Service Letter No. 370

SUBJECT: Modification to Engine Breather Line

MODELS AFFECTED: PA-24 and PA-24 "250" Comanches - Serial Numbers 24-2175, 24-2299 to 24-2675 incl., 24-2677 to 24-2801 incl., 24-2803, 24-2804, 24-2806, 24-2808 to 24-2888 incl., 24-2890 to 24-2935 incl., 24-2937, 24-2939 to 24-2943 incl., 24-2945 to 24-2948 incl., 24-2950 to 24-2956 incl., 24-2958 to 24-2966 incl., 24-2969 to 24-2982 incl., 24-2984, 24-2986 to 24-2989 incl., 24-2991, 24-2992, 24-2994 to 24-3005 incl., 24-3007 to 24-3009 incl., 24-3011, 24-3012, 24-3014, 24-3016, 24-3018, 24-3020 to 24-3023 incl., 24-3027 to 24-3040 incl., 24-3042, 24-3043, 24-3046 to 24-3049 incl., 24-3052, 24-3055, 24-3059, 24-3060, 24-3062, 24-3068.

SERVICE LETTER NO 370

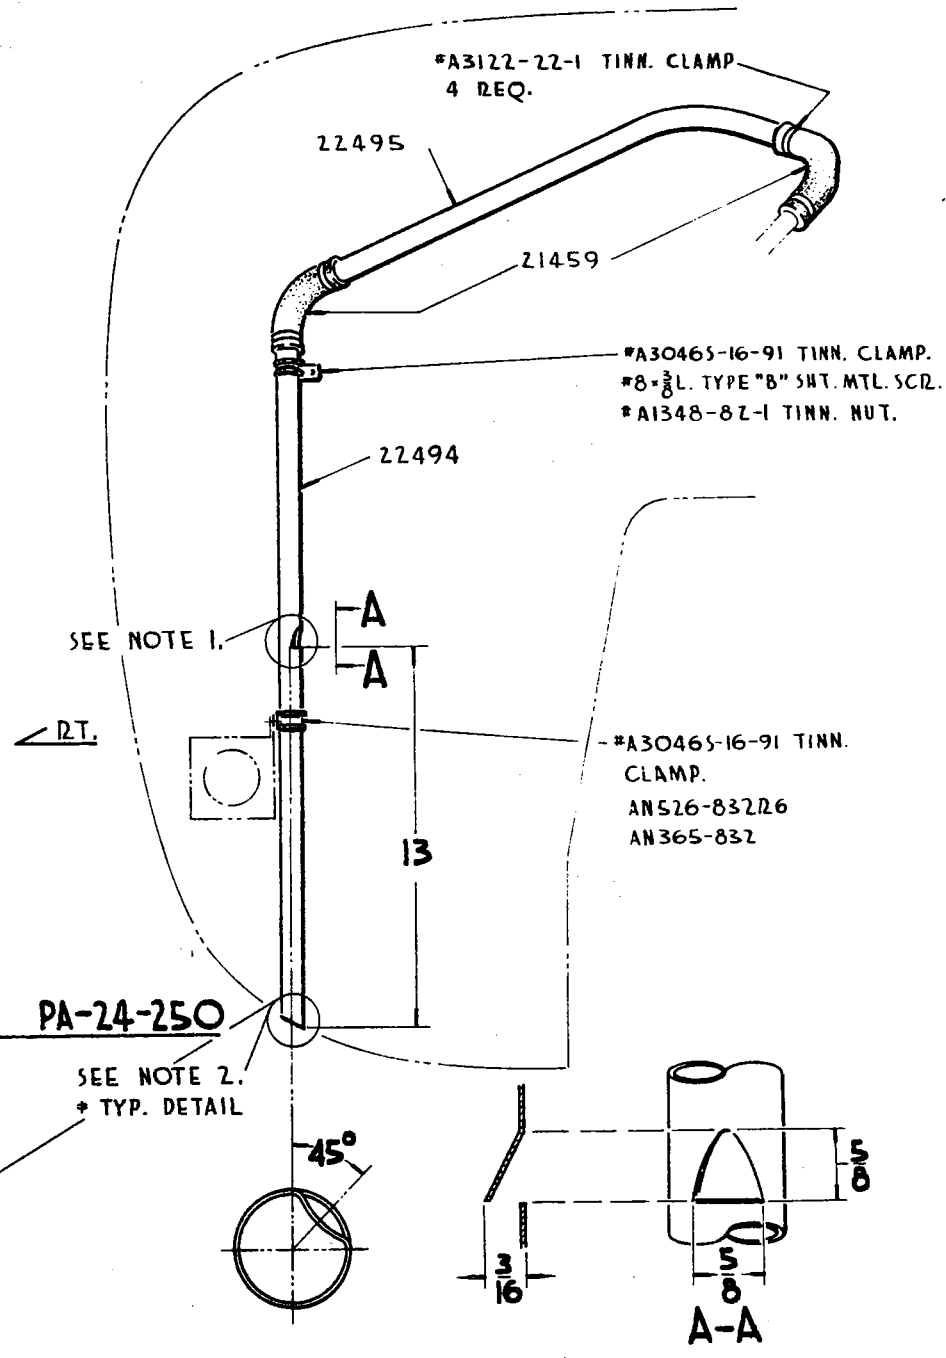
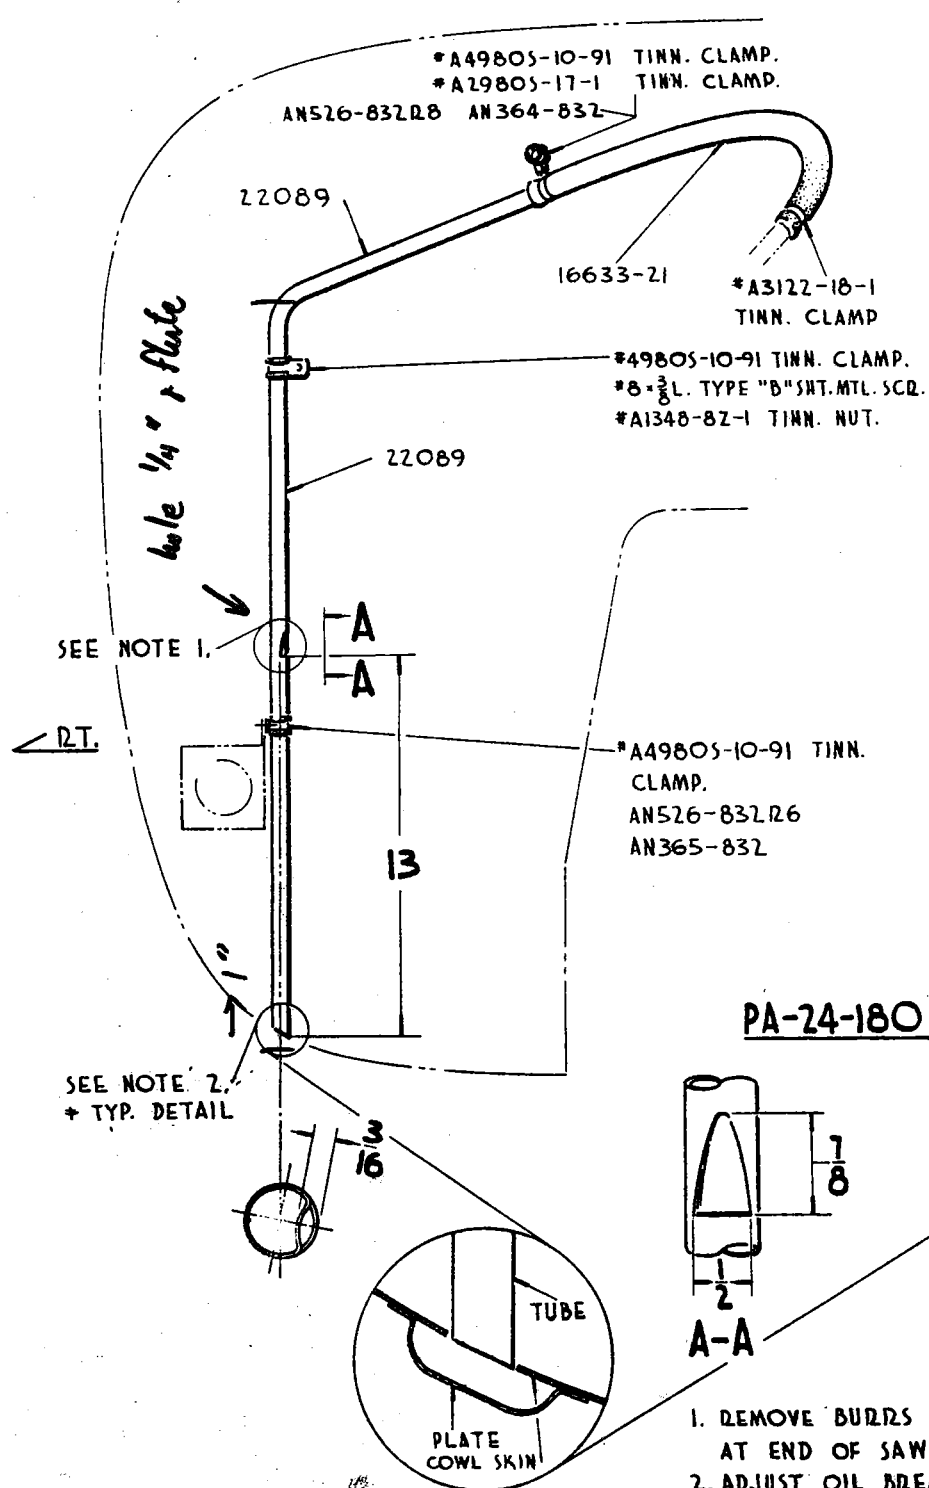
A few reports have been filed with the Service Department indicating that the engine breather line on the subject aircraft may extend below the opening in the bottom cowl.

The engine breather line should be inspected and, if necessary, adjusted so that it is flush with the bottom cowl. Refer to sketch on the reverse side of this Service Letter. The adjustment of this breather line, flush with the bottom cowl, will prevent the accumulation of ice at the opening of the engine breather line and in the scoop into which it vents.

As a precautionary measure, for operations in extensive icing conditions it is recommended that the engine breather line be modified to provide an alternate vent. This modification consists of a saw-cut across the engine breather line and forming the area above the saw-cut as shown in the sketch on the reverse side of this Service Letter.

NOTE: CARE SHOULD BE EXERCISED WHILE FORMING THE VENT
SO THAT THE TUBE IS NOT FLATTENED OR DISTORTED.

1. REMOVE BURRS THAT MAY BE FORMED AT END OF SAW SLOT.
2. ADJUST OIL BREATHER TUBE FLUSH WITH SKIN.
